MEMORANDUM

TO: District of Columbia Board of Zoning Adjustment
FROM: Karen Thomas, Case Manager
JLS
for Joel Lawson, Associate Director Development Review
DATE: June 28, 2016

SUBJECT: BZA Case 19241 - request for special exception relief under § 223 to allow a porch and sunroom addition in the R-2 District.

Partial Deck and Porch addition viewed from 50th Place.

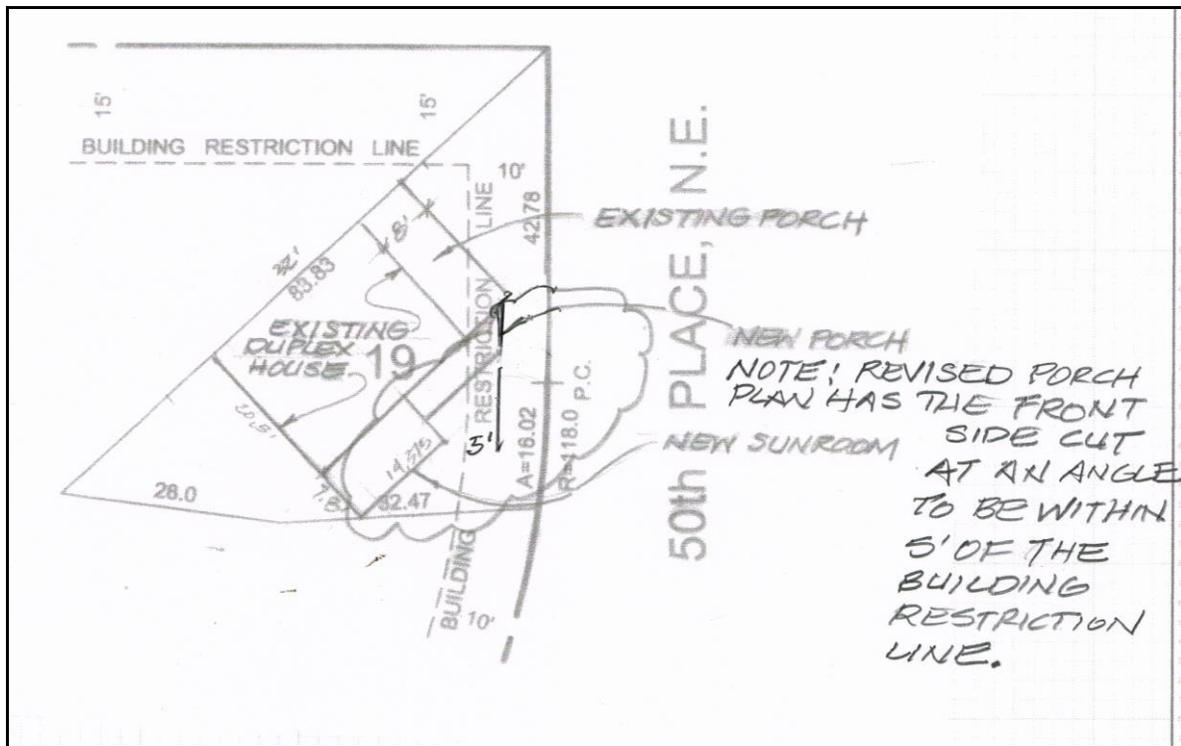
The one-story sunroom and attached porch would be visible from 50th Place. However, it would not appear out of character with respect to the scale and pattern of homes as viewed from public space.
